Subject: **Response to NCDWR On Hold Letter dated May 9, 2019** for the extension and relocation of NC 84 from NC 16 to SR 1008 (Waxhaw-Indian Trail Road) in Union County. Federal Aid Project No. STP-1316(10), WBS 39019.1.1, Division 10, TIP No. U-3467.

Reference: 404/401 Individual Permit Application dated February 21, 2019
NCDWR On Hold Letter dated May 9, 2019

**LOCATION: SR 1316 (REA ROAD EXTENSION)
FROM NC 16 TO SR 1008**

DRAINAGE REDLINES
CALYX – 4-22-2019
PM – D. BOCKER
DE – A. THOMPSON

PROJECT REFERENCE NO. U-3467		SHEET NO. 4	
RW SHEET NO.		HYDRAULICS ENGINEER	
ROADWAY DESIGN ENGINEER		HYDRAULICS ENGINEER

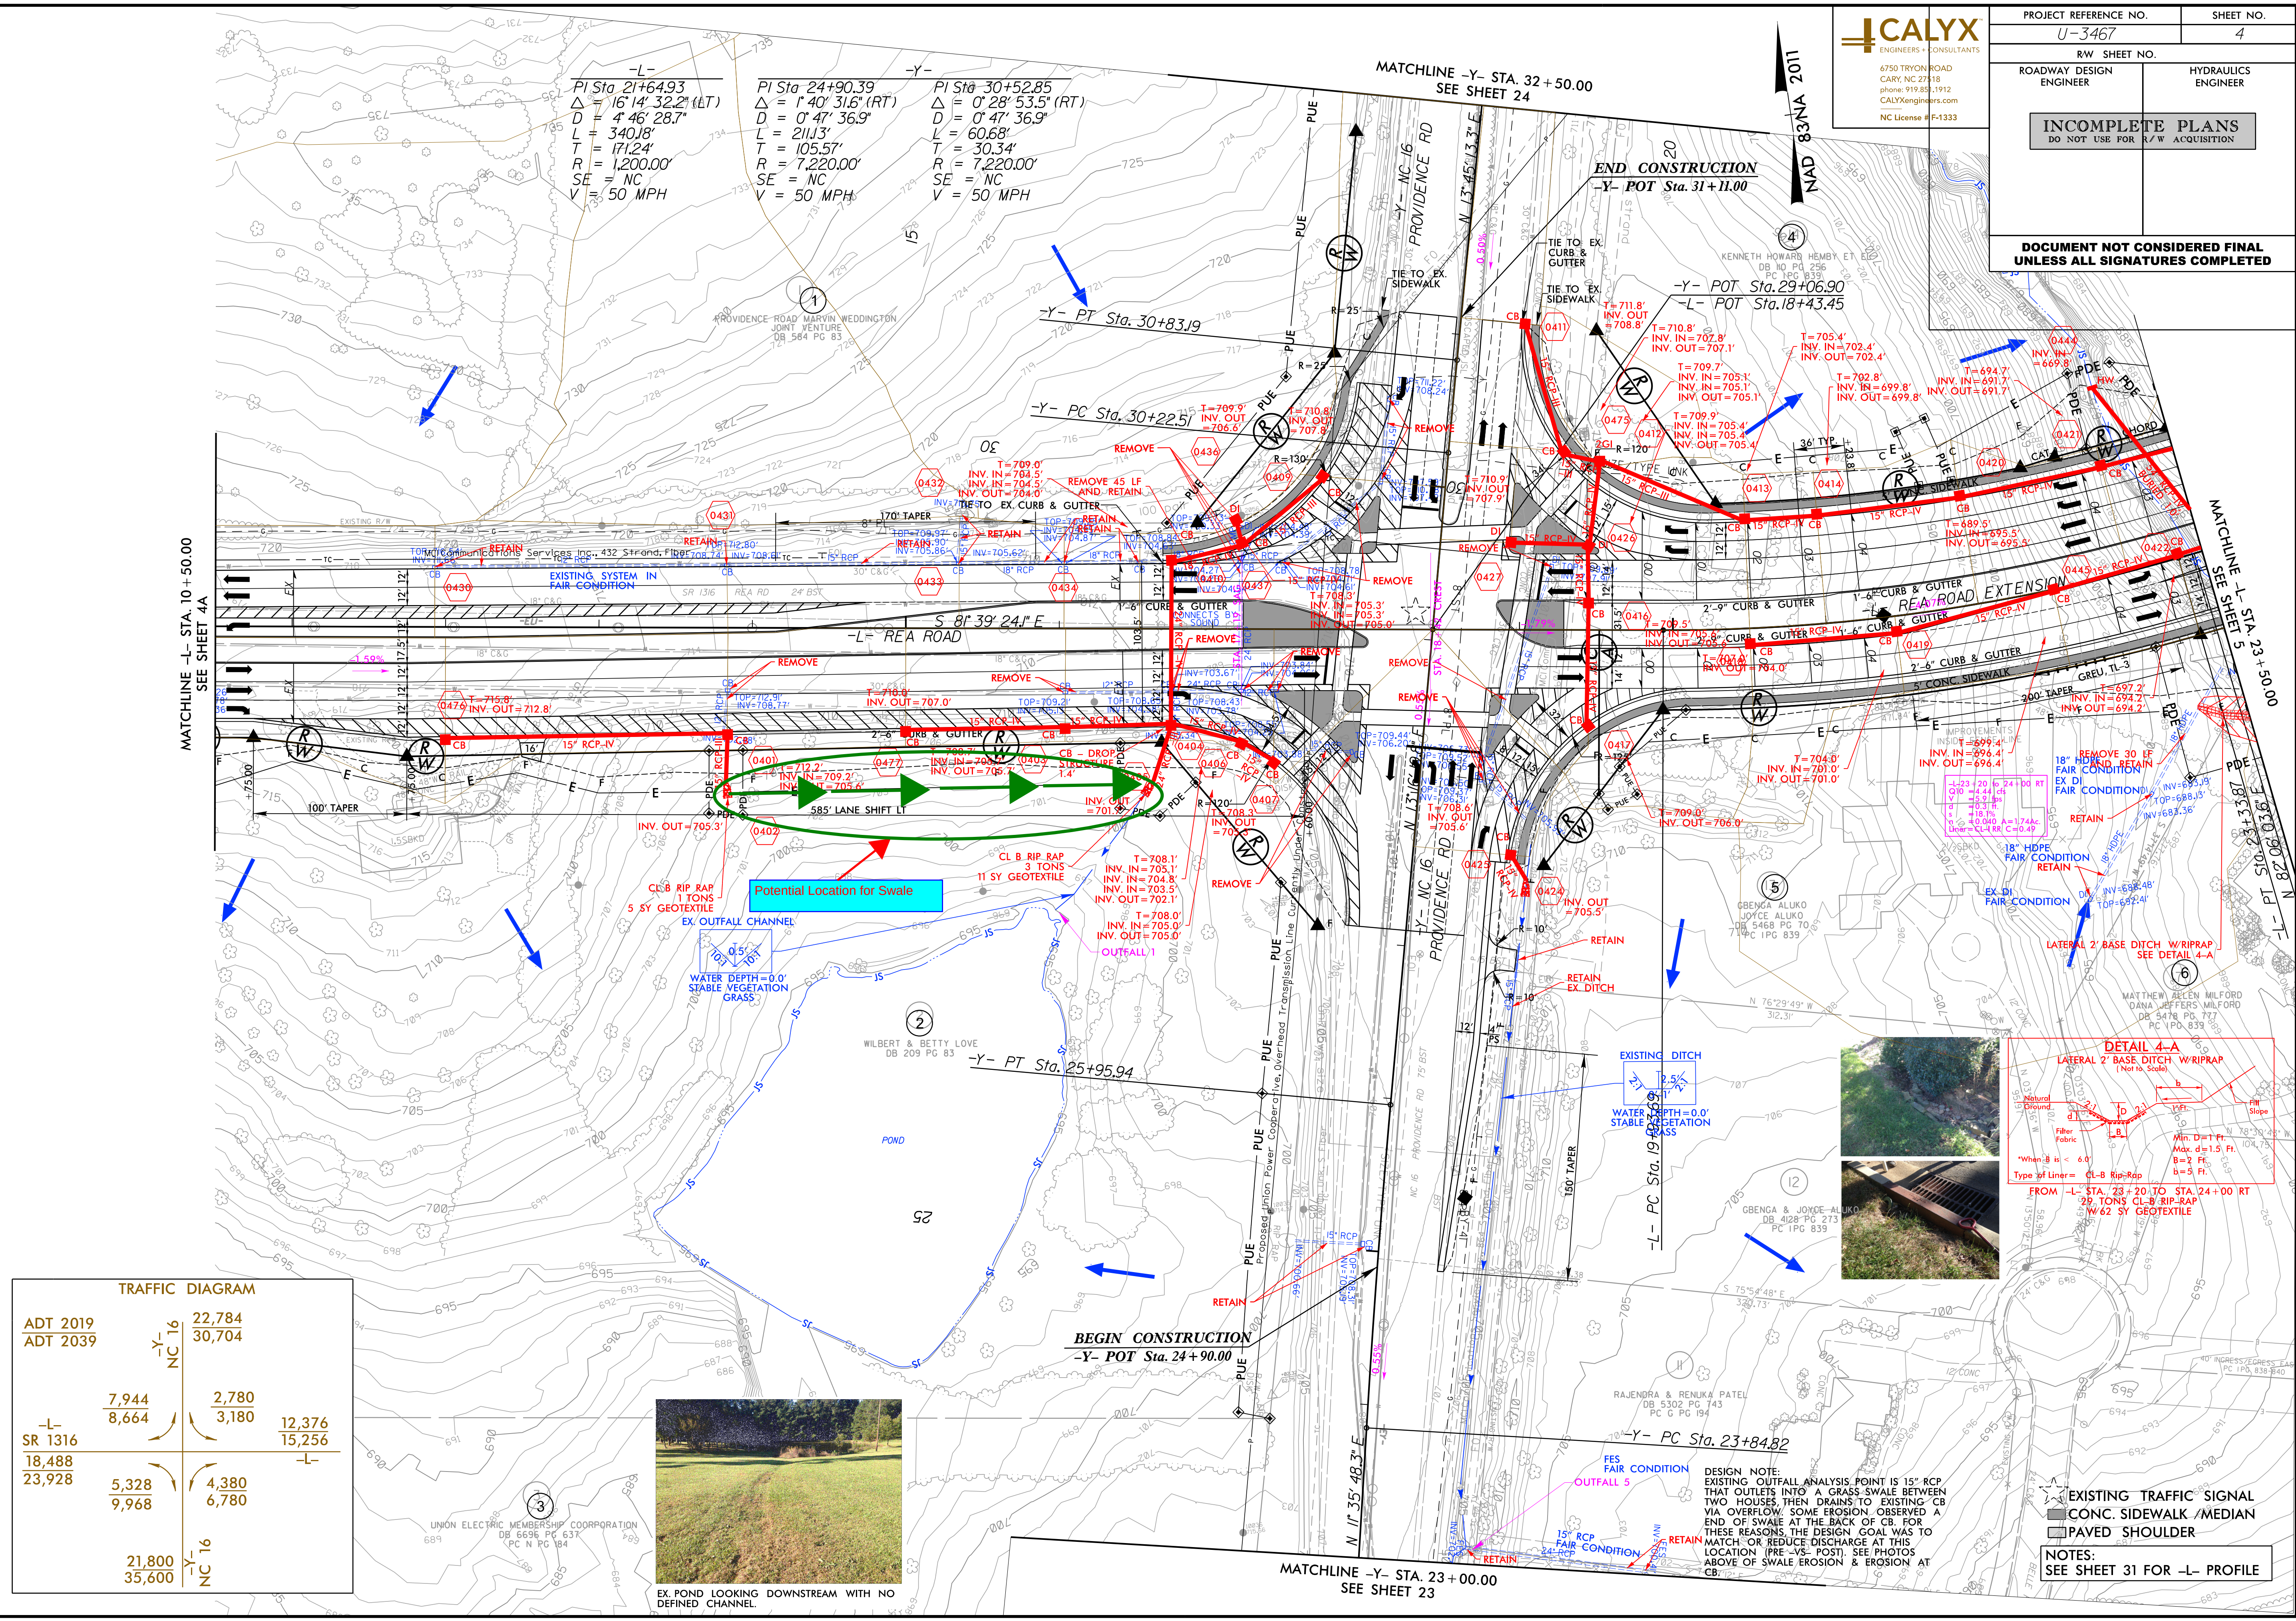
- Plan sheet 4: This swale would have to extend a significant distance downhill to get the appropriate depth and would extend well beyond the proposed ROW.

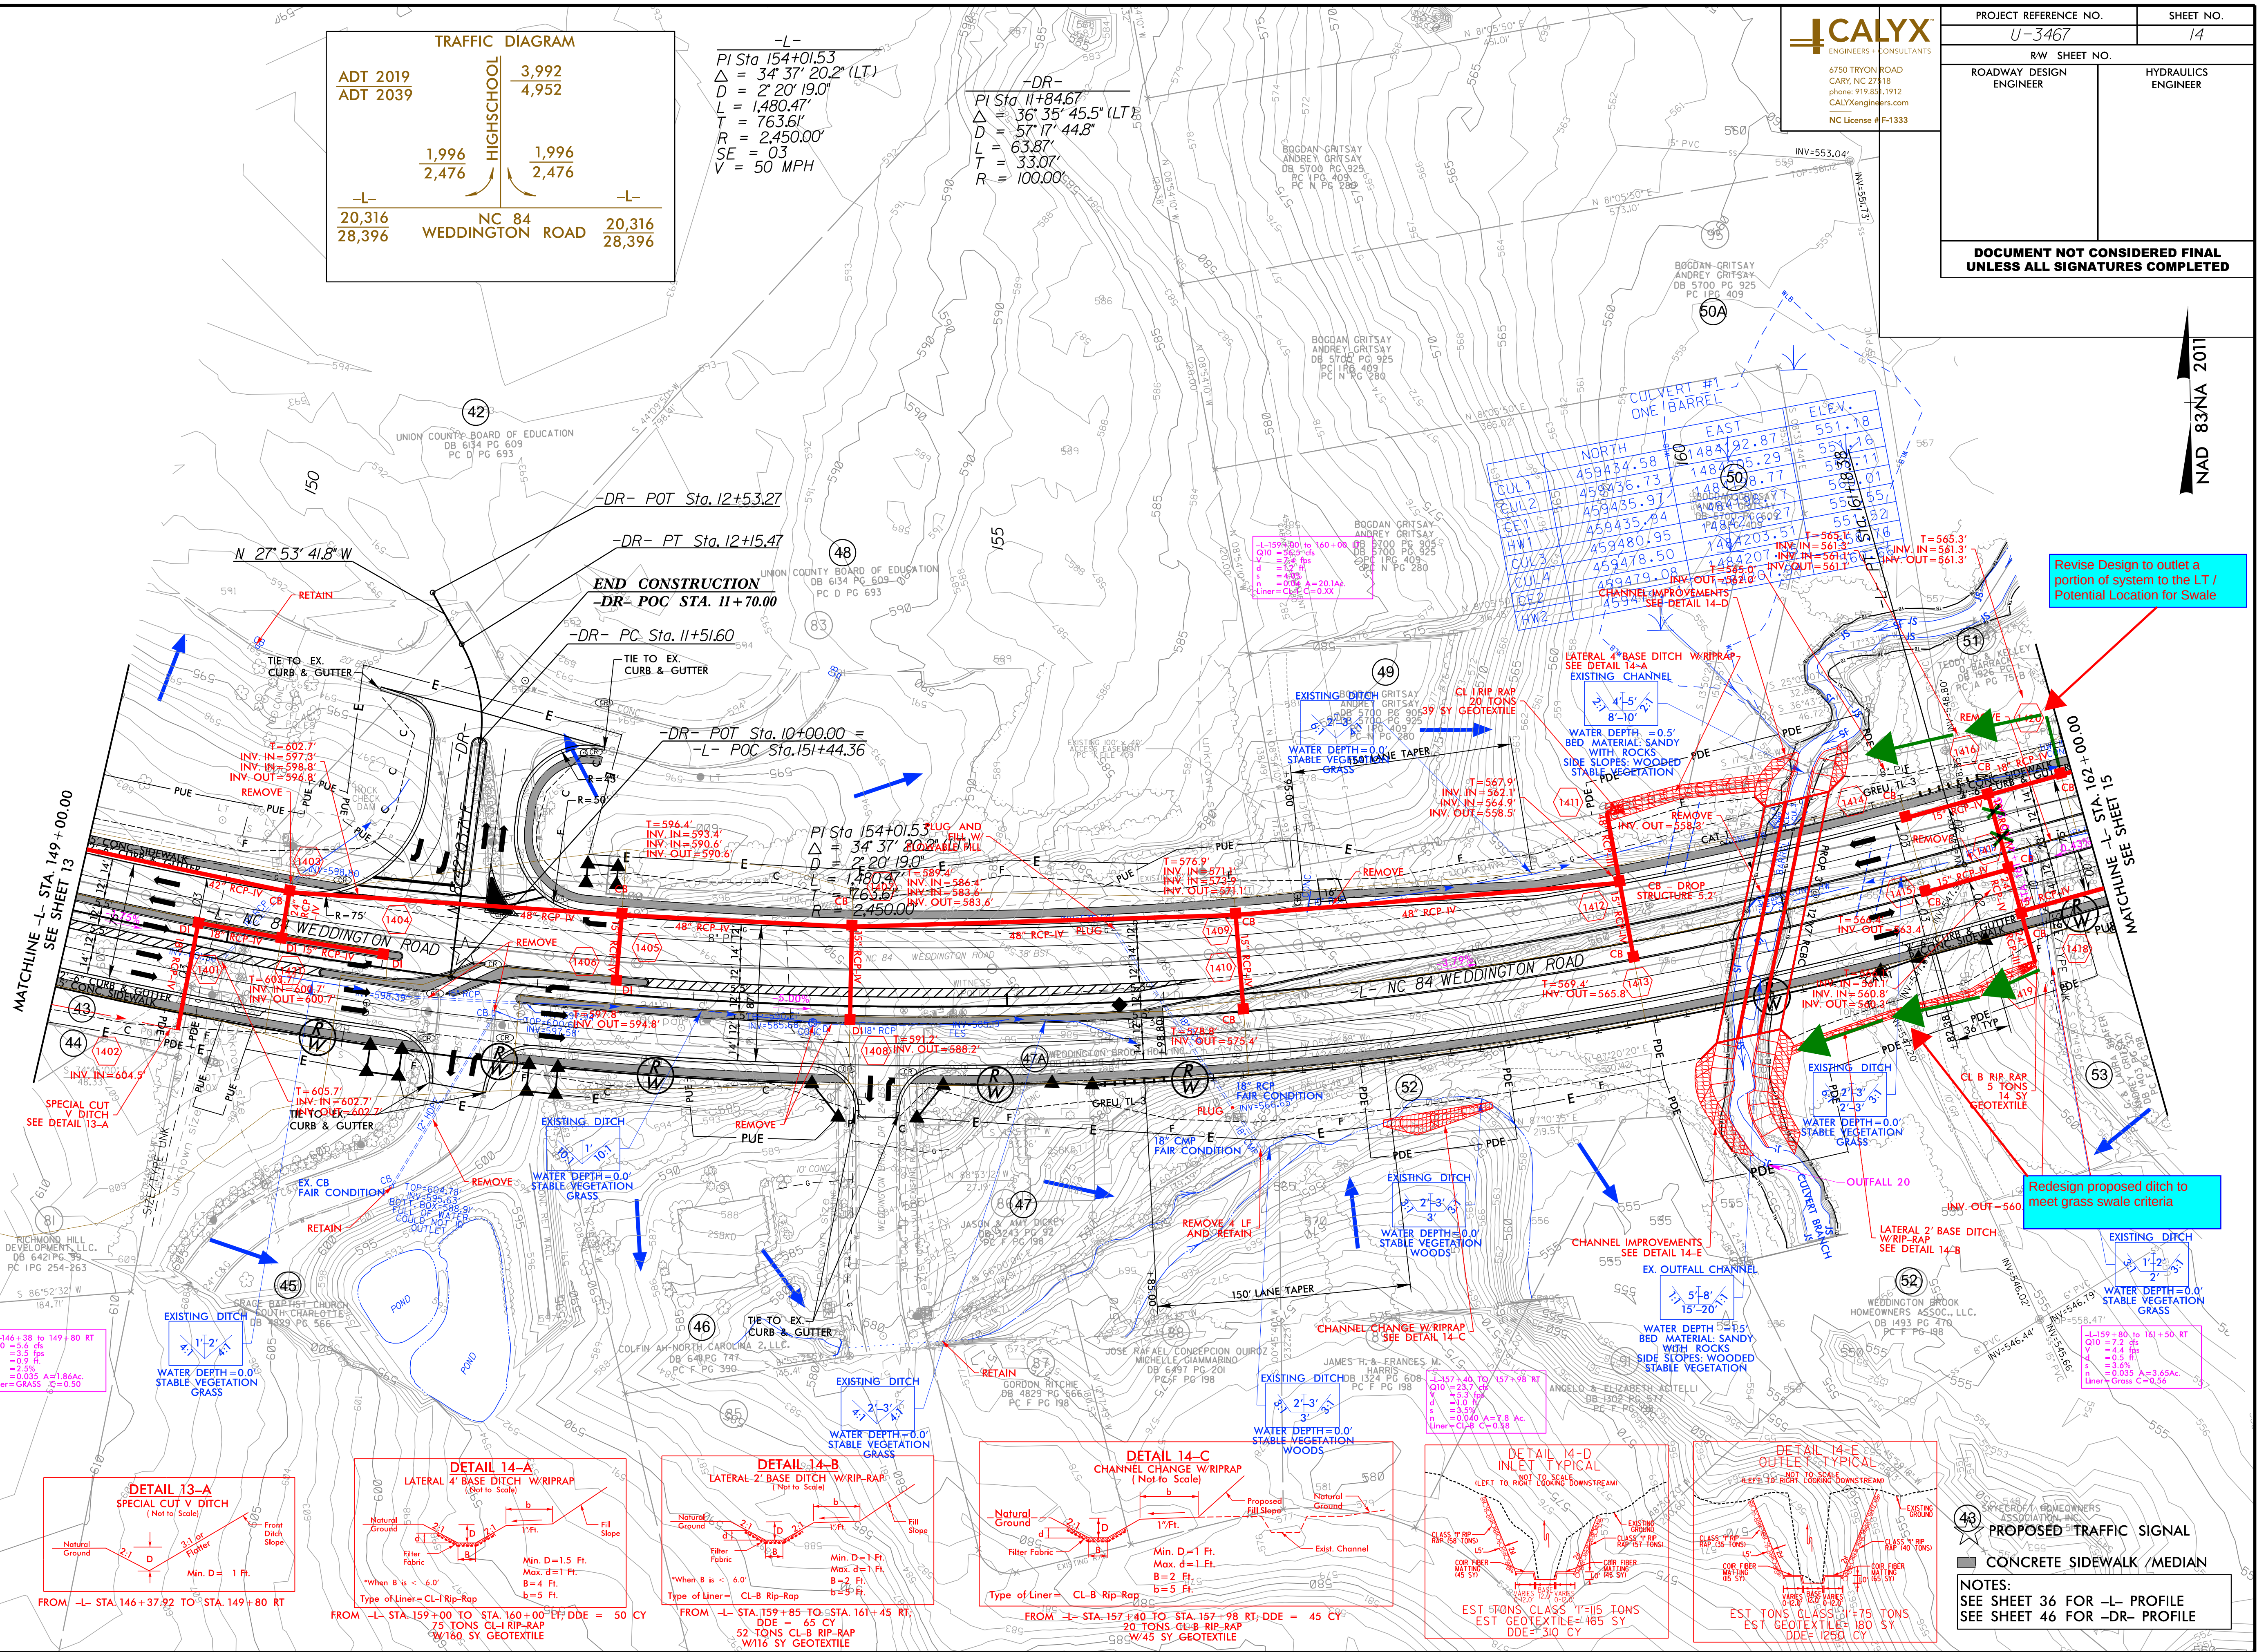
- Plan sheet 14, north and south side: This area has steep slopes leading down to Culvert Branch. The proposed ditch from -L- Sta. 159+85 to Sta. 161+46 Rt. has a 3.6% slope and a high velocity. Installing a swale on either side of the road in this location would require an extensive cut to flatten out the ditch to meet swale criteria. Additionally, the swales would extend past ROW.

- Redesign proposed ditch to meet grass swale criteria

- Redesign proposed ditch to meet grass swale criteria
